SEMINOLE COUNTY GOVERNMENT
1101 EAST FIRST STREET, 2ND FLOOR, WEST WING
SANFORD, FLORIDA 32771

PROJECT NAME:	VILLAGE PL - PRE-APPLICATION	PROJ #: 24-80000034
APPLICATION FOR:	DR - PRE-APPLICATION DRC	
APPLICATION DATE:	3/07/24	
RELATED NAMES:	EP BRENDA PEARCE	
PROJECT MANAGER:	KATHY HAMMEL (407) 665-7389	
PARCEL ID NO.:	03-21-29-5WA-0000-0010	
PROJECT DESCRIPTION	PROPOSED SPECIAL EXCEPTION FOR A NEW WATER METER SYSTEM INSTALLATION ON 75.97 ACRES IN THE PD ZONING DISTRICT LOCATED ON THE EAST SIDE OF VILLAGE PL, NORTH OF WEKIVA SPRINGS RD	
NO OF ACRES	75.97	
BCC DISTRICT	3: CONSTANTINE	
CURRENT ZONING	PD	
LOCATION	ON THE EAST SIDE OF VILLAGE PL, NORTH OF WEKIVA SPRINGS RD	
FUTURE LAND USE-	PD	
APPLICANT:	CONSULTANT:	
BRENDA PEARCE BLACK & VEATCH/SUNSHINE WATER 200 WEATHERSFIELD AVE ALTAMONTE SPRINGS FL 32714 (678) 656-5179 PEARCEB@BV.COM	N/A

PROJECT AREA ZONING AND AERIAL MAPS

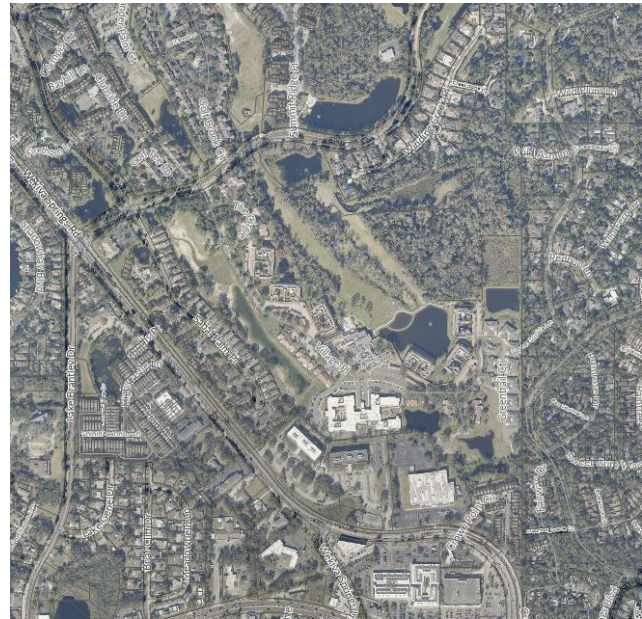
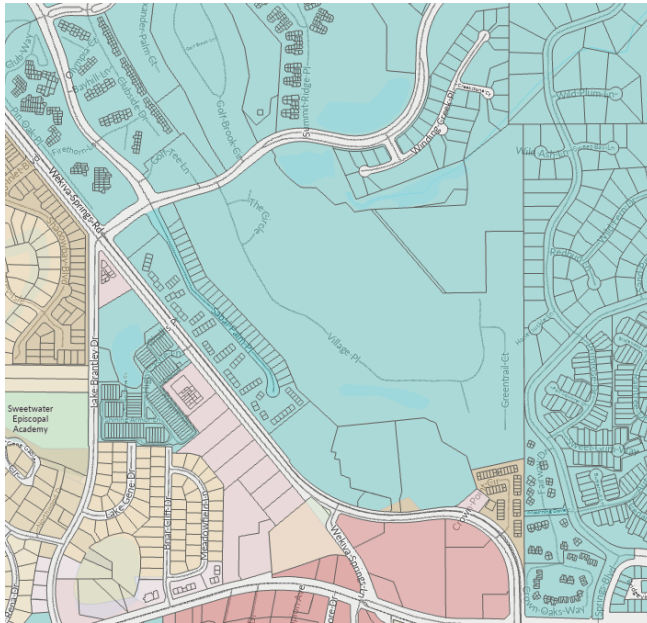
The parcel is located within unincorporated Seminole County and within the Village on the Green, Sabal Point Planned Development (PD).

The installation of a pole with an antenna for a new water metering system will require a Major Amendment to allow the use in the PD. A variance to the building/structure height of 35 feet may also be required.
